No. EL/3.1.35/2 Electrical

MODIFICATION SHEET NO. RDSO/2012/EL/MS/ 0411 (Rev.1), Dated 2.11.12.

Modification sheet to avoid simultaneous switching ON of White and Red marker light in three phase locomotives.

MODIFIED CIRCUIT DIAGRAM OF MARKER LIGHT.

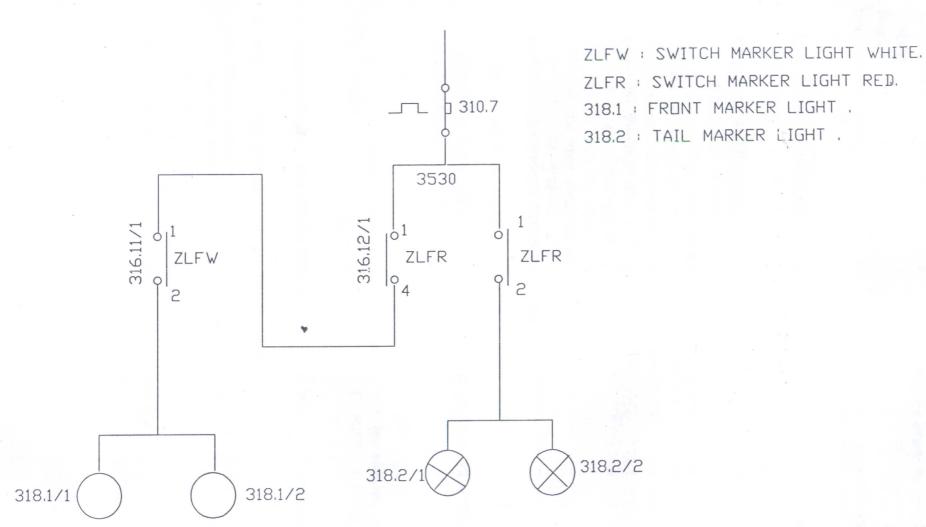
In the modified circuit, as shown in annexure-II, one NC auxiliary contact of switch marker light Red (Sch. Pos.316.12/1) is connected in series with NO auxiliary contact of switch marker light White (Sch. Pos.316.11/1) and all the links as indicated in the Rev.'0' of the modification sheet are taken out. Similar connections are to be done in other cab.
